Access Compliance Report Public Rights-of-Way (Curb Ramps)

Main Street: BEACH_BLVD Cross Street: MIDWAY_PL Location: NE

ADA ID: RPRK210929154331 Ramp Type: Type 1 - Perpendicular Diagonal Initial Pass/Fail: Fail Overall Compliance: No Severity Score: 30

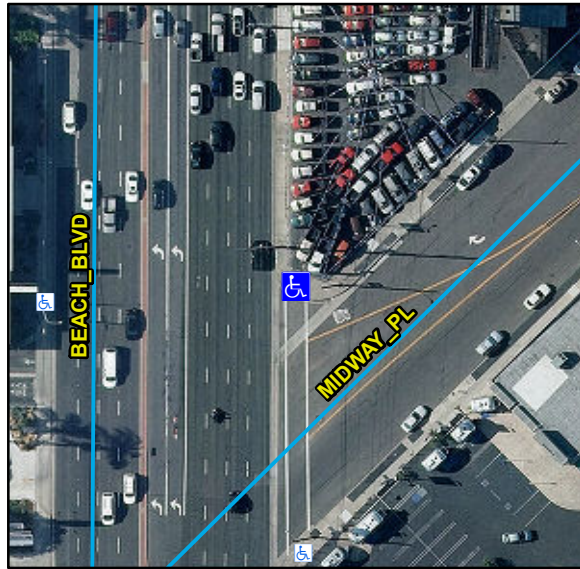
Compliance	Description	Data	Compliance	Description	Data
N/A	Ramp Length (in)	120	N/A	Flare Type LT	
Yes	Ramp Width (in)	48			N/A
Yes	Ramp Run Slope (%)	1.4	N/A	Flare Slope LT (%)	N/A
No	Ramp Cross Slope (%)	11.2	N/A	Flare Traversable LT	N/A
N/A	Landing Present	N/A	N/A	Flare Type RT	
N/A	Landing Length (in)	N/A			N/A
N/A	Landing Width (in)	N/A	N/A	Flare Slope RT (%)	N/A
N/A	Landing Run Slope (%)	N/A	N/A	Flare Traversable RT	N/A
N/A	Landing Cross Slope (%)	N/A	N/A	DWS Provided	N/A
N/A	Landing Movement Obstructed?	N/A	N/A	DWS Contrast	N/A
	Landing Movement Type	N/A	N/A	DWS Length (in)	N/A
N/A	Landing Shared	N/A	N/A	DWS Full Width	N/A
N/A	Clear Space	Yes	N/A	DWS Offset Left (in)	N/A
N/A	Clear Space To Crosswalk (in)	N/A	N/A	DWS Offset Right (in)	N/A
N/A	Marked Crosswalk 1	No	N/A	Marked Crosswalk 2	No
	Crossing 1 Direction	W		Crossing 2 Direction	S
	Marked Crosswalk 1 Width (in)	N/A		Marked Crosswalk 2 Width (in)	N/A

Remove & Replace Curb Ramp With Two New Directional Ramps or Equivalent.
